**BLUEMOUND ROAD
CORRIDOR:
ROAD SAFETY AUDIT**

September 2007

FIGURE 4.1 PROPOSED MEDIAN NOSE CONFIGURATION

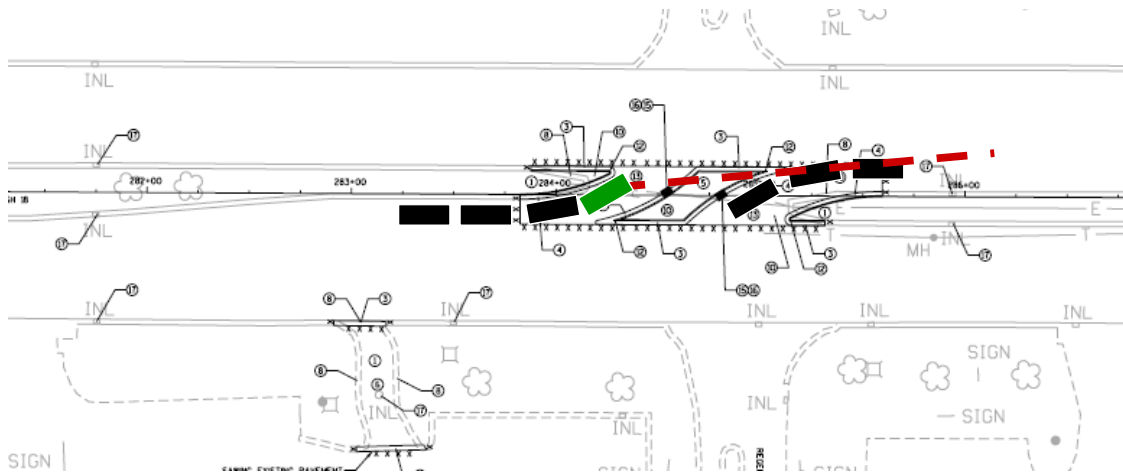
Safety Issue 2 Description: Current design drawings indicate an extremely short distance between the opposing turn lanes within the dual restricted median openings. This layout can limit the view of opposing through traffic for drivers turning left or making a u-turn. Opposing vehicles waiting to turn left partly block sightlines between left-turn drivers and opposing through traffic (especially vehicles in the left through lane). This view of oncoming traffic can be further obstructed when a large truck is in the opposing turn lane. Drivers who cannot see approaching vehicles may attempt to turn left across the path of an oncoming vehicle, which may increase the risk of left-turn collisions. FIGURE 4.1 below illustrates this safety issue.

Increase the distance between the median openings to at least 100-feet and preferably 150-feet. This will enhance the sight distance for drivers looking to make left- or u-turn within the dual restricted median openings. By enhancing the sight distance the risk of left-turn and rear end collisions will be significantly reduced.

Bluemound Road near Marcus Drive

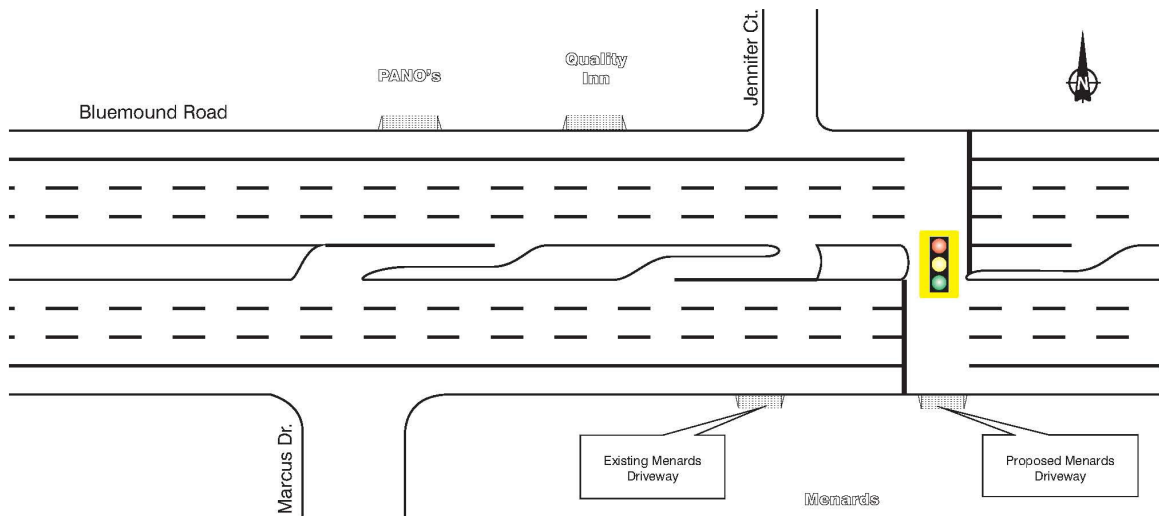
Safety Issue 3 Description: On westbound Bluemound Road the queue from the signal at Barker regularly extends 450 feet (according to the Earth Tech reports) which is beyond the existing signal at Marcus Drive. This was one of the reasons why the traffic signal at Marcus Drive is proposed to be relocated to the intersection of Bluemound and Jennifer.

Once the signal is relocated, eastbound drivers turning left at a median break into Pano's will have to cross four opposing lanes of traffic. This maneuver may generate eastbound left-turn and rear end conflicts with opposing through vehicles. The potential for collisions is further increased when drivers turn left through the traffic queued back from the signal at Barker Road. This in combination with the issues associated with the close proximity of the proposed dual restricted median openings which were discussed in Safety Issue 2, makes this eastbound left-turn movement a concern.

- ◆ Close the median opening for eastbound Bluemound into Pano's.
- ◆ Close the direct left-turn lane for Jennifer and create a single eastbound restricted median opening between Jennifer and Marcus.
- ◆ Move the proposed signal at Jennifer to the east so it is aligned with the northeast corner of the Menards parking lot.

These changes which are illustrated on the following page will provide reasonable access to all of the businesses along this section of Bluemound Road while eliminating the need for drivers to cross four lanes of opposing traffic through the queue for Barker Road. In addition this will increase the distance between this signal and the Barker Road signal which should help with the corridor progression. While this change may not be feasible for this project, it should be considered for the 2012 Bluemound Road reconstruction project.

Bluemound Road near Fiserv Drive

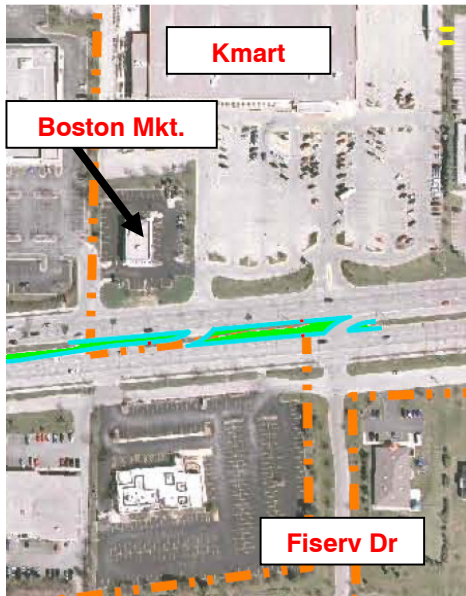
Safety Issue 4 Description: Restricting access to these sites may cause drivers to take indirect routes, make U-turns at signalized intersections, or drive through parking lots, to reach the sites. Indirect routes may increase volumes on other roads that may not have sufficient capacity; U-turns at signalized intersections are illegal and may contribute to an increased risk of collision at the intersection (particularly with a conflicting right-turn movement); parking lots are not intended for through traffic, and through traffic, which is likely to be traveling at higher speeds, may conflict with pedestrians walking to and from their vehicles, and vehicles entering and exiting parking stalls. Locations in which these observations apply include:

Realigning proposed median breaks to provide direct access to the K-Mart and Boston Market driveways and Fiserv Drive would reduce the need for drivers to access these sites indirectly. This layout is illustrated on the following page.

FIGURE 4.2 PROPOSED MEDIAN NOSE CONFIGURATION

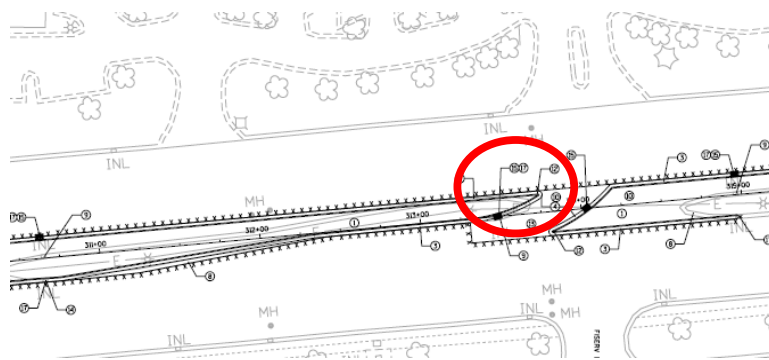
Safety Issue 5a: With the changes in geometrics for the corridor, it is expected that the volumes of u-turning vehicles along the corridor will increase due to the elimination of many of the direct left-turn on to Bluemound Road. The proposed median nose configuration may orient vehicles to make left-turns. U-turns within the proposed median configuration may be more difficult due to the pointed median nose (*below*).

It is suggested that a more rounded nose configuration be considered for the median openings on Bluemound Road. A more rounded nose will make it easier for drivers to make u-turns.

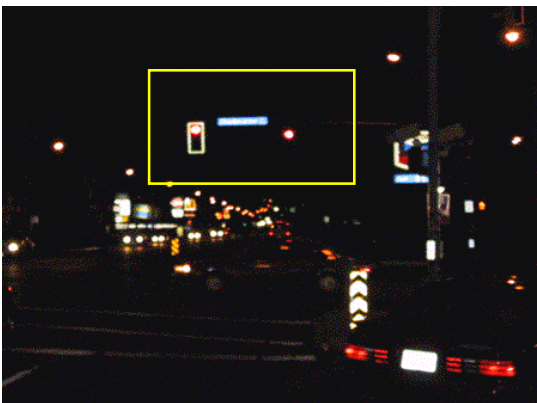
Safety Issue 7 Description: The use of a single overhead signal head limits signal (and intersection) conspicuity for drivers approaching the intersection, and may limit signal visibility for drivers whose view of the single overhead display is compromised by a tall vehicle (such as a truck) ahead, or affected by a bright rising or setting sun. The risks associated with limited signal and intersection conspicuousness is greatest at the intersection with Barker Road, where drivers' view of the intersection on several approaches is limited by vertical and horizontal curves. Drivers who fail to observe the signal display increase the risk of angle and rear-end collisions. The risk is also increased for older drivers, whose visual and decision-making abilities are reduced.

1. *Provide a redundant signal display on each approach.* The use of multiple overhead signal displays on a single approach enhances signal conspicuity, provides redundancy in the event of signal failure or damage, and may improve signal visibility. Redundancy may be achieved by providing multiple signal overhead heads (such as one signal head over each approach lane).
